## **ASPECT INDUSTRIAL ESTATE MODIFICATION 9 (SSD-10448 MOD 6) & STAGE 4 DEVELOPMENT MOD 2 (SSD-60513208) RESPONSE TO REQUEST FOR ADDITIONAL INFORMATION**

This response letter has been prepared by Urbis on behalf of Mirvac Industrial Developments Pty Ltd (Mircac) (**the Applicant**) in response to various requests for additional information (**RFI**) dated 8 April 2025 from the Department of Planning, Housing and Infrastructure (**DPHI**) and the comments issued by the supporting government agencies, in connection with the above modification and SSD Application for Warehouse 8 at the Aspect Industrial Estate (**AIE**).

An extract from the civil drawings of the updated substation location is provided in the figure below.

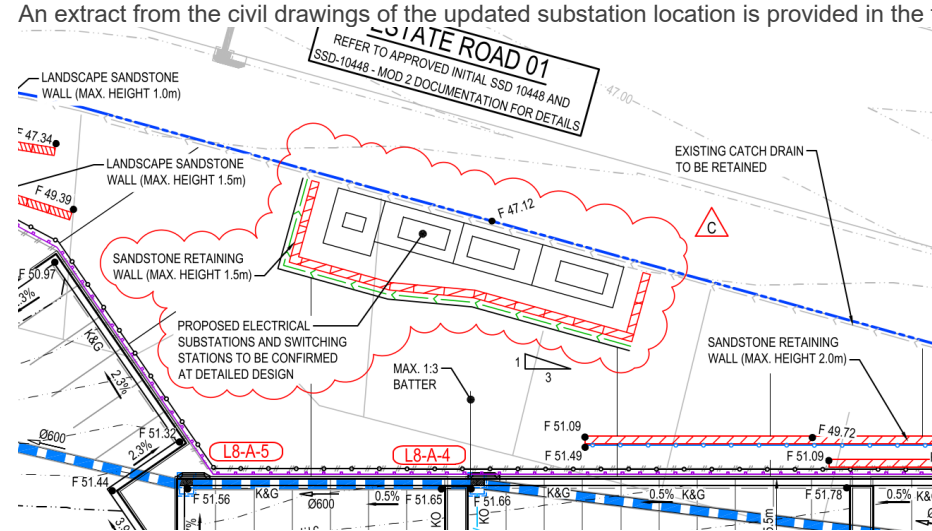
SSD-60513208. The architectural plans indicate the substation is located within the building setback along the northern elevation of the lot fronting Access Road 1. However, it has been brought to the Department's attention that design changes would be required to ensure compliance with Endeavour Energy's access requirements. This would result in a reduction in landscaping fronting Access Road 1 and is not supported by the Department. The Applicant is required to update the architectural plans to show the substation located adjacent to Access Road 1 within the landscape setback. The Applicant must update any conditions which are to be revised in regard to the location of the substation.

An extract of EE's construction standards under MCI006 is provided below, demonstrating that the substation location behind the building setback was not appropriate:

*Substations must be located wholly within and at the front property boundary with unrestricted 24 hour a day employee and vehicle access to the substation directly from a public street."*

As such, the substation at Warehouse / Lot 8 is to be located adjacent to Access Road 1 within the landscape setback, with the introduction of a sandstone retaining wall (max height of 1.5m) to facilitate the change in elevation in the area. This is reflected in the relevant plans, including:

The figure below demonstrates the poor design and amenity outcome that would have been required if the substation were to be maintained in its approved location and not relocated to be located adjacent to Access Road 1 within the landscape setback.

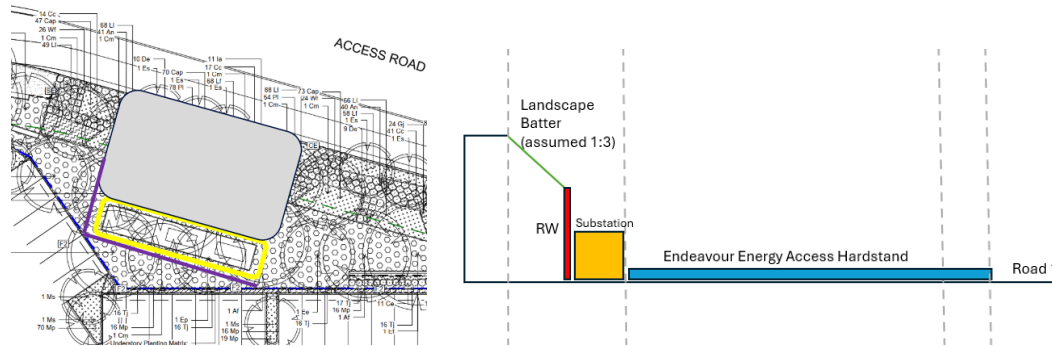
- The updated substation location removes the requirement for additional, access hardstand to be introduced between Access Road 1 and the substation, which would have had significant, adverse impacts to the design and amenity outcome, including:
  - A loss of 246.17m<sup>2</sup> of landscaping.
  - A loss of 203.42m<sup>2</sup> in canopy cover.
  - The introduction of a larger retaining wall, which would be approx. 2m taller than the proposed sandstone retaining wall proposed as part of the relocated substation design.

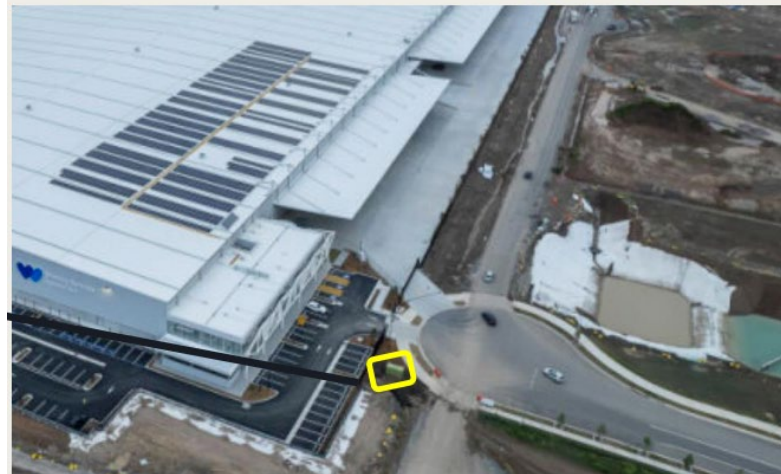
- The updated substation location will not adversely impact the canopy coverage at Warehouse / Lot 8. As detailed in the row above, the proposal inclusive of the relocated substation, will result in an increase to the on-lot tree canopy coverage compared to the approved development, and will continue to achieve the 10% on-lot tree canopy coverage requirement.
- The updated substation location aligns with the substation locations that have been approved and delivered across the rest of the AIE which are located at the public street frontage. This is demonstrated in the figure below.

The proposed substation relocation represents a sensible design solution that meets EE's requirements and delivers an improved design, amenity and landscape outcome compared to the alternative design solution required had the substation be located within the building setback.
